Access Compliance Report

Public Rights-of-Way

(Curb Ramps)

Intersection ID: 53390	Main Street: KELBURN_LN	Cross Street: AGNEW_DR	Location: NW
ADA ID: 08C20B964598	Ramp Type: BlendTrans1	Initial Pass/Fail: Fail	Overall Compliance: No
Severity Score: 10			
Codes/Mitigation Info/Possible Solution		Field Measurements/Component Compliance

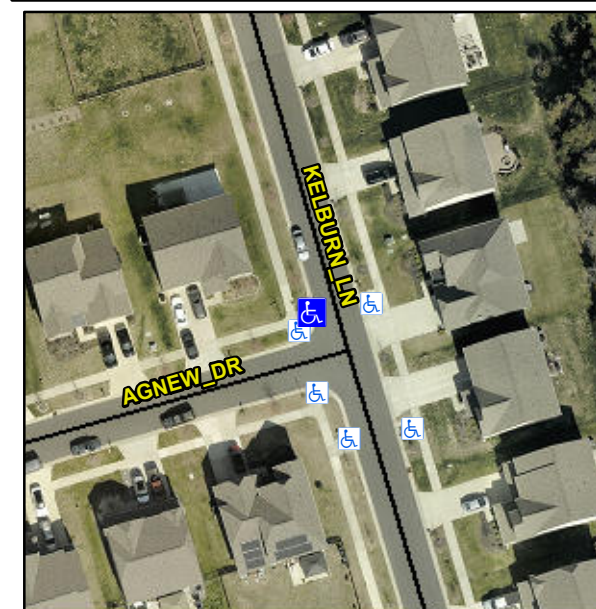
R304.5.1, R304.5.3

Compliance	Description	Data	Compliance	Description	Data
N/A	Ramp Length (in)	97.0	Yes	BlendTrans Slope (%)	3.8
No	Ramp Width (in)	46.5	No	BlendTrans XSlope (%)	3.6
N/A	Flare Type LT	N/A	N/A	Flare Type RT	N/A
N/A	Flare Slope LT (%)	N/A	N/A	Flare Slope RT (%)	N/A
N/A	Flare Traversable LT?	N/A	N/A	Flare Traversable RT?	N/A
N/A	Landing Length (in)	N/A	N/A	DWS Provided?	N/A
N/A	Landing Width (in)	N/A	N/A	DWS Contrast?	N/A
N/A	Landing Slope (%)	N/A	N/A	DWS Length (in)	N/A
N/A	Landing X Slope (%)	N/A	N/A	DWS Full Width?	N/A
N/A	Landing Curb? (Y/N)	N/A	N/A	DWS Offset (in)	N/A
N/A	Shared Landing?	N/A			
N/A	Gutter Ponding?	N/A	N/A	Gutter Slope (%)	N/A
N/A	Gutter Lip Ht (in)	N/A	N/A	Gutter X Slope (%)	N/A
N/A	Painted X Walk1?	No	N/A	Painted X Walk2?	N/A
	X Walk 1 Direction	To NE		X Walk 2 Direction	N/A
	X Walk 1 Width (in)	N/A		X Walk 2 Width (in)	N/A
	X Walk 1 Slope (%)	2.6		X Walk 2 Slope (%)	N/A
	X Walk 1 X Slope (%)	1.5		X Walk 2 X Slope (%)	N/A

Remove & Replace Curb Ramp With Two New Directional Ramps or Equivalent.
